SJRWMD and SWFWMD Responses to Stakeholder Comments on the Draft Central Springs Groundwater Flow Model (CSM) version 1.0

January 31, 2024

Figure 6. Reverse Particle Tracking from Blue Spring using the CSM.

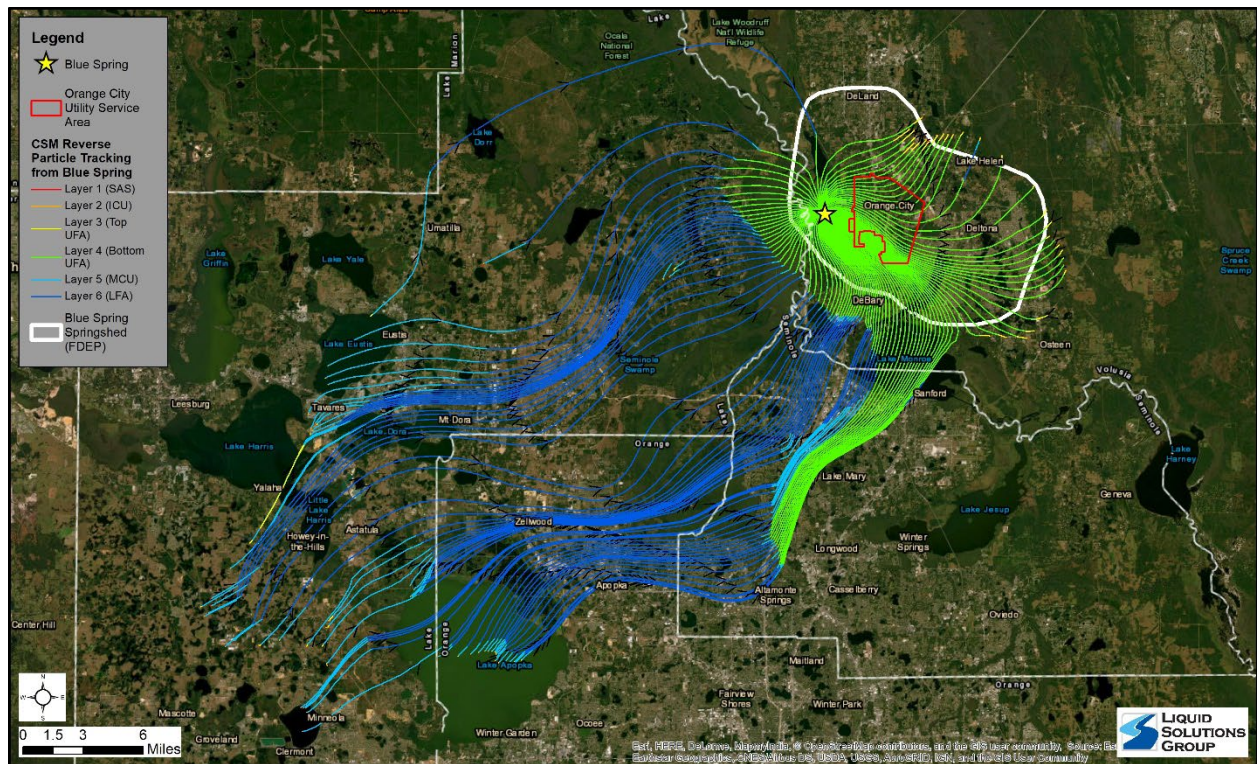
As shown in **Figure 6**, Blue Spring’s contributing area simulated by the CSM extends to areas in west Orange County and Lake County. In fact, approximately 55% of the simulated contributing area appears to originate from Orange and Lake counties. Hence, a review of Blue Spring’s simulated springshed is warranted.

Response: A springshed is typically delineated using a UFA potentiometric surface and/or groundwater flow model simulation representing a hydrological "snapshot" of a certain time period. The boundary of a springshed can vary significantly due to changes in hydrological and climatic conditions. For this reason, the model development team does not think it is appropriate to use an estimated springshed boundary to inform a regional model calibration or verify model parameters.

Figure 7. CSM’s Simulated Dry Cells in the Layer 4 (Bottom UFA) near the City and Blue Spring.

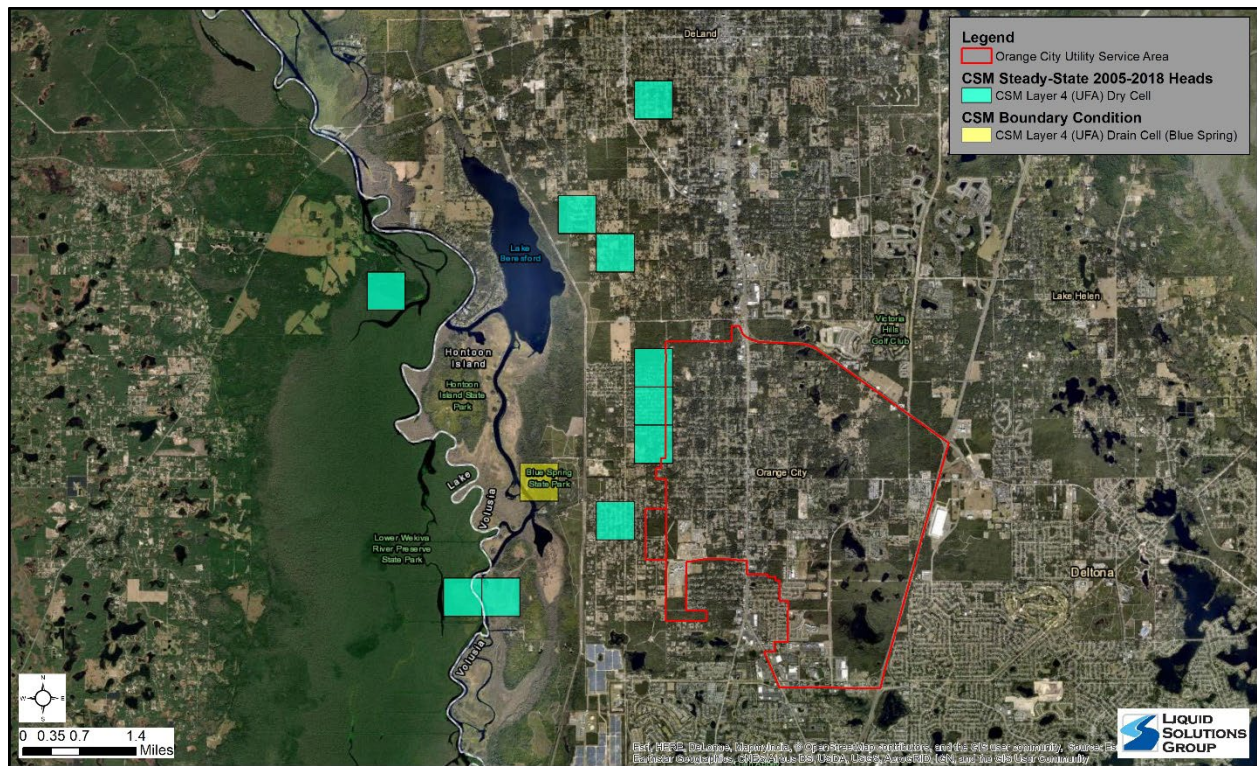
4. Both the steady-state and transient versions of the CSM produce “dry” cells in the UFA (CSM’s Layer 3 and Layer 4), in the vicinity of the City’s utility service area and near Blue Spring. For reference, **Figure 7** shows the distribution of dry cells near the City and Blue Spring simulated by the CSM steady-state simulation in Layer 4. The presence and potential impact of these dry cells on groundwater flow simulated in the vicinity of the City’s utility service area and Blue Spring should be investigated and mitigated.

Response: Areas in which layer 1 is dry generally correspond to regions where the SAS and/or ICU are thin or completely absent. The large areas of dry cells in the western part of the model domain are expected as the UFA in this area is unconfined and the water table can be greater than 100 feet below land surface. The occurrence of dry cells in the CSM outside of these areas and within other layers may be attributed to a lack of nearby water level observations available to guide the calibration process. Dry cell distribution in western Volusia County, which includes the City's service area, will be reviewed as a part of CSM v1.1 modeling effort.

Figure 8. CSM’s Simulated Dry Cells in the Layer 4 (Bottom UFA), Model-Wide.

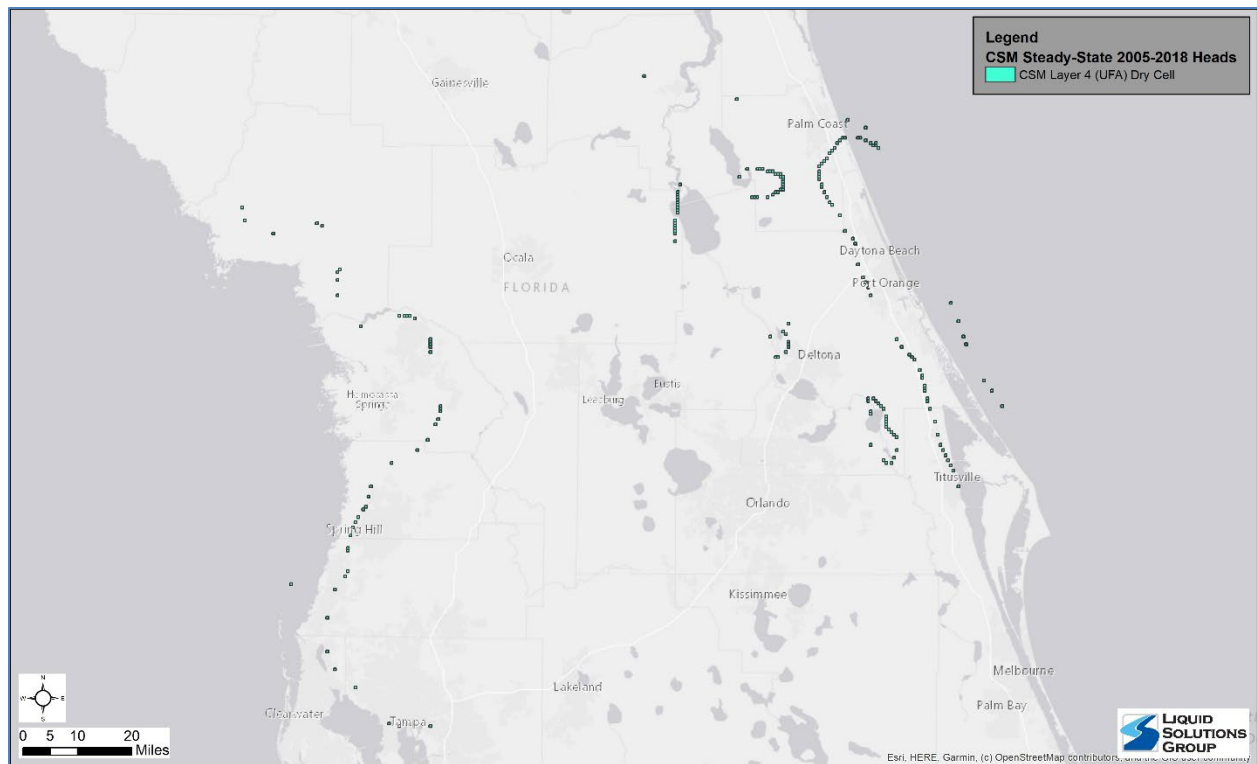
Also for reference, additional dry cells were also detected throughout the CSM’s active domain in all layers. For reference, **Figure 8** shows dry cells in CSM’s Layer 4 for the full model domain.

Figure 1. Representation of the wells located within The Villages in the CSM Model

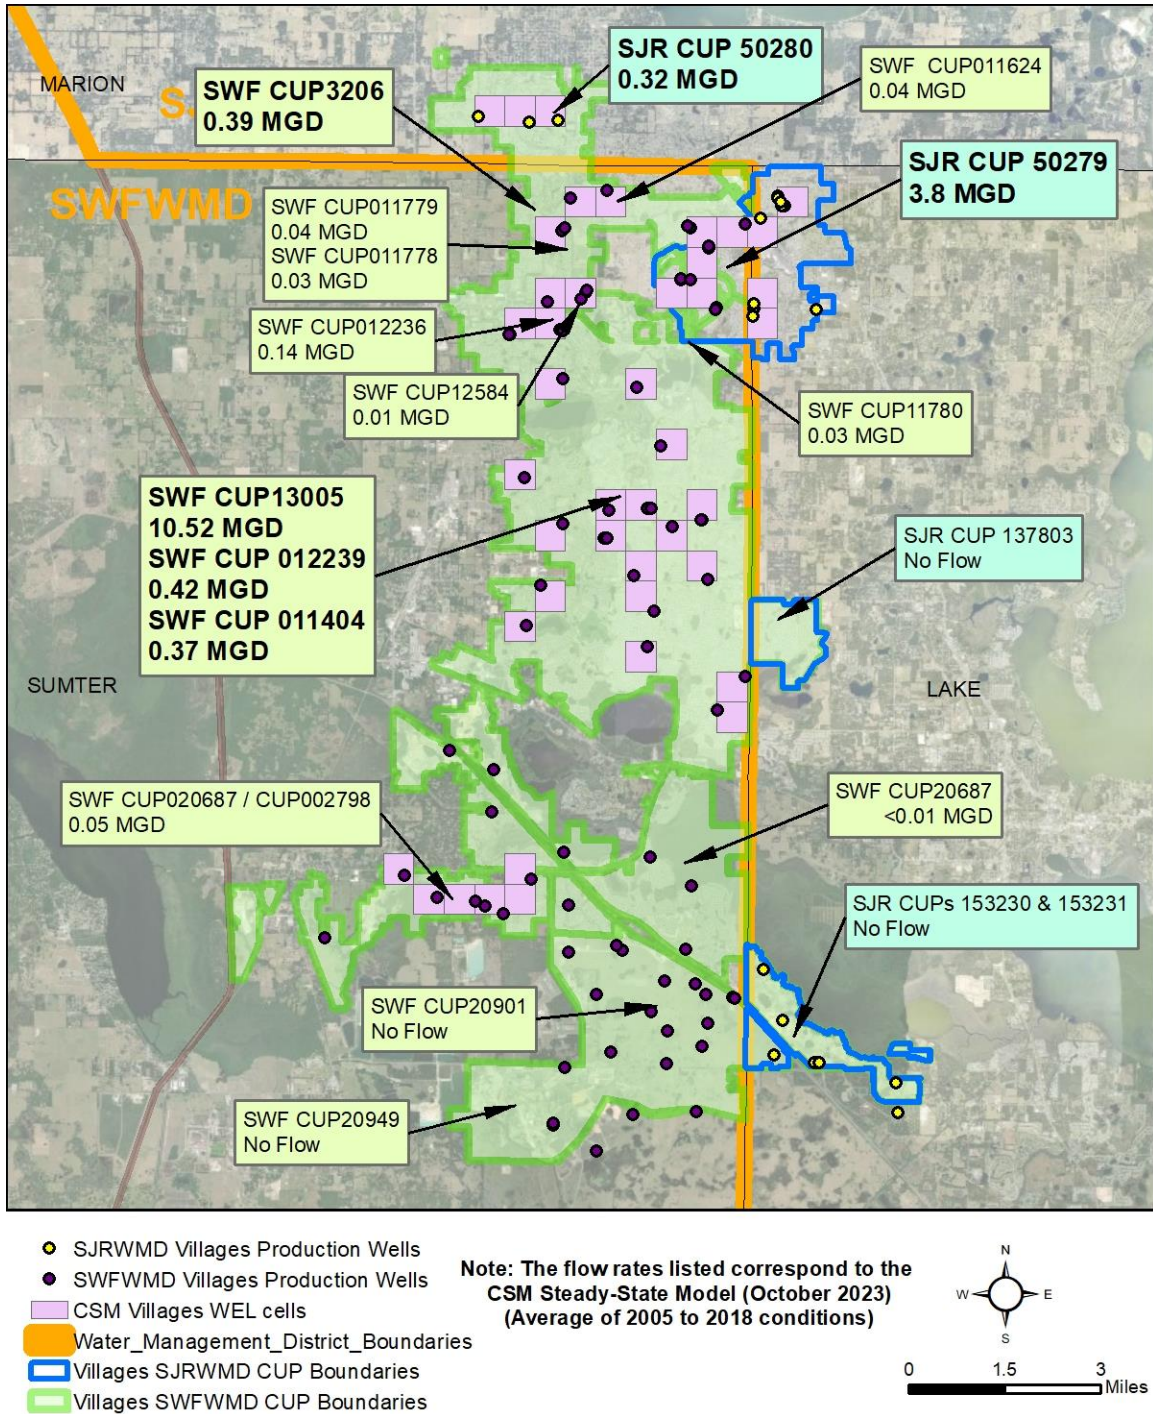
As shown in **Figure 1**, there is excellent correspondence between the model cells and the locations of the production wells. Some more recently permitted wells are not included in the model, which is to be expected given the period of record (2005 to 2018).

Table A-1 in **Appendix A** compares the well casing and total depths to the model layer elevations and layer assignments used in the CSM model for the production wells within The Villages in SWFWMD. Most of the wells were assigned to the correct model layer, but the errors and minor corrections are summarized in **Table 1**.

Response: The identified well layering errors will be corrected in CSM v1.1. Documentation was added to the CSM report regarding the assignment of model layers to permitted wells in the well file. If further discrepancies are discovered, please provide well construction documentation to the appropriate district so that information in the corresponding well construction database can be updated with the correct information. This will ensure accurate model layer assignment in future model well files.

Figure 4. Upper Floridan Aquifer Transmissivity and APT Comparison

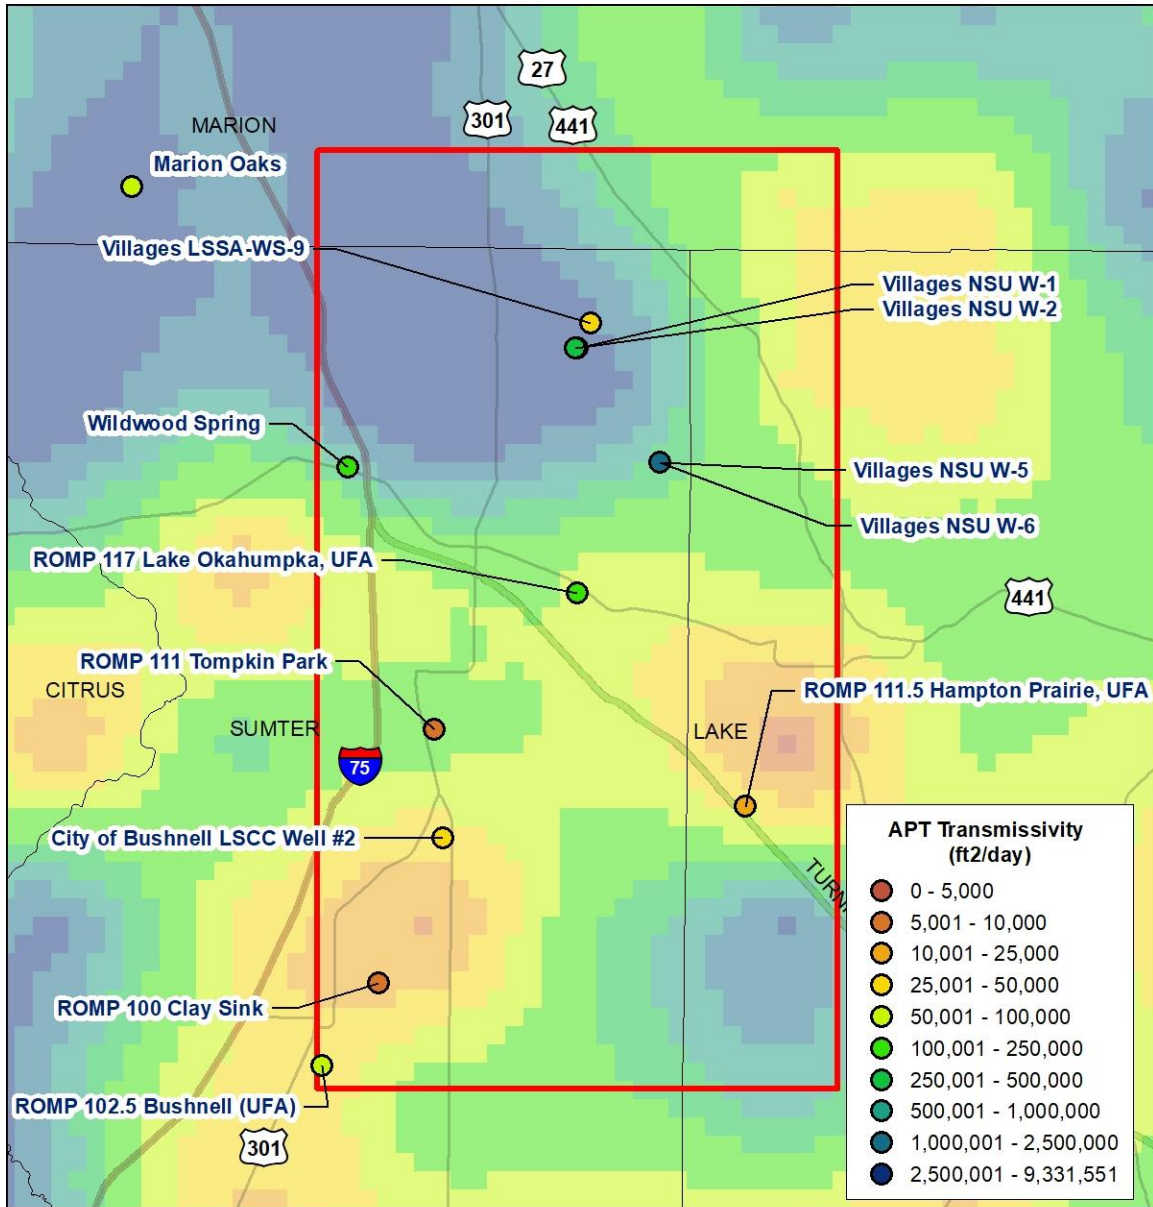
Figure 4 shows a comparison between the UFA Transmissivity of the CSM model (Layers 3 and 4) relative the locations of Aquifer Performance Test (APT) data. In The Villages vicinity, there is significantly more variability in the UFA transmissivity values in the CSM compared to the range of values in the APT data. Several bull's eyes are evident in the central-south portion of the area of interest, which suggests that the calibration process may have made significant changes from the initial values in this area.

Response: APT data from WUP/CUP applicants served as guidance at the regional level during the CSM calibration process. Additional text was added to Chapter 4 regarding the reasoning behind the qualitative rather than quantitative comparison between APT-derived and model calibrated aquifer parameters. Although APT-based parameters were used qualitatively in the CSM, it is possible that parameters from selected APTs may be utilized as quantitative constraints in a future version of the model.

Figure 5. Lower Floridan Aquifer Transmissivity and APT Comparison

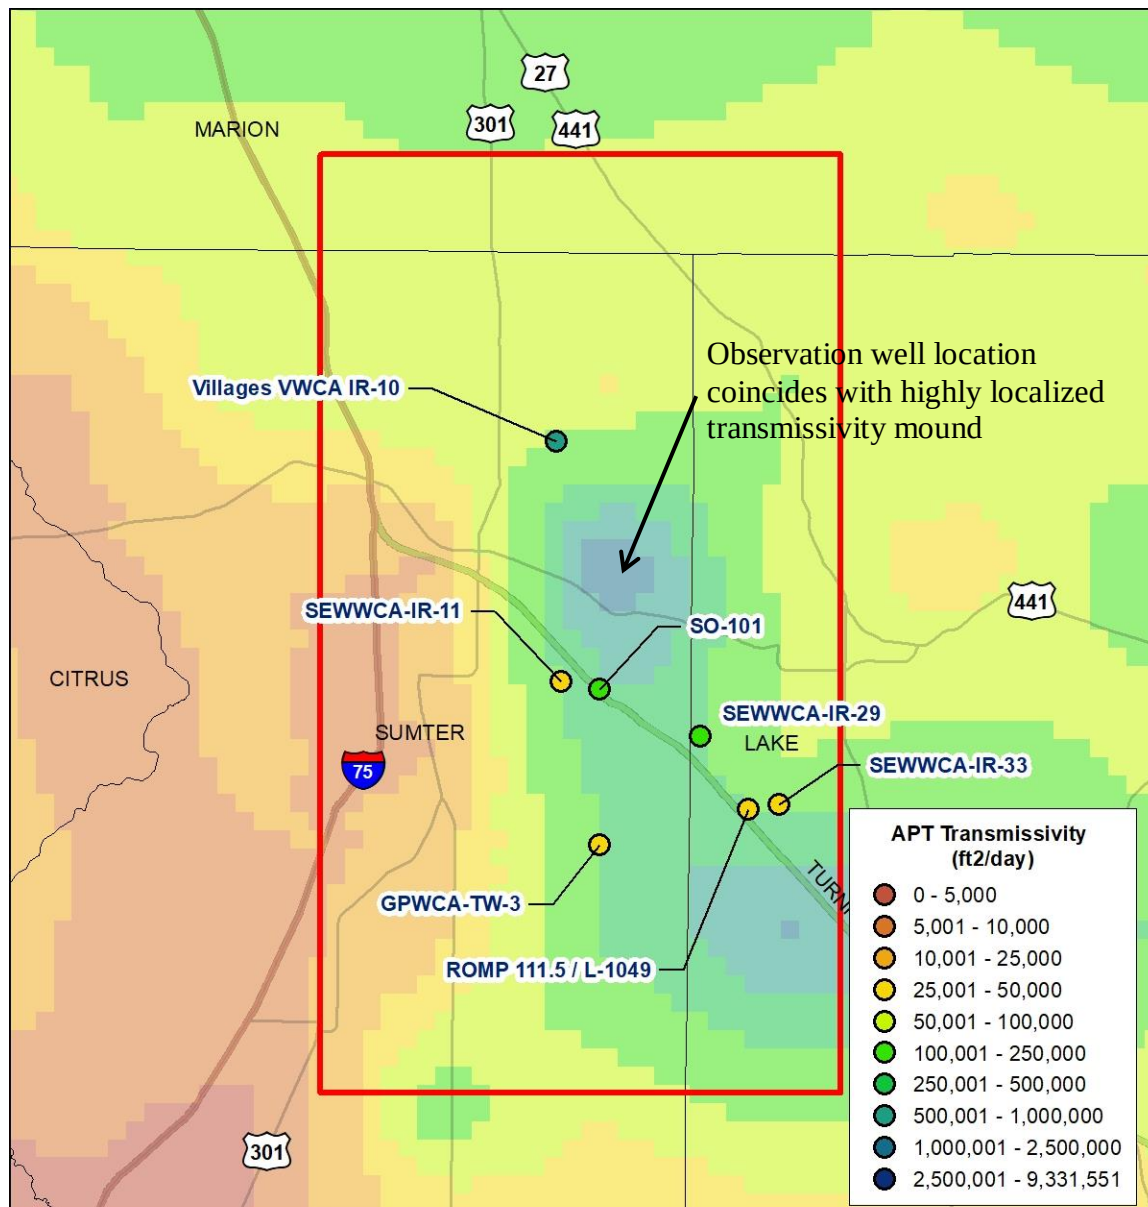
Figure 5 shows a comparison between the LFA Transmissivity of the CSM model (Layers 3 and 4) relative the locations of Aquifer Performance Test (APT) data. Similar to the UFA, there are considerable differences between the CSM and the APT values.
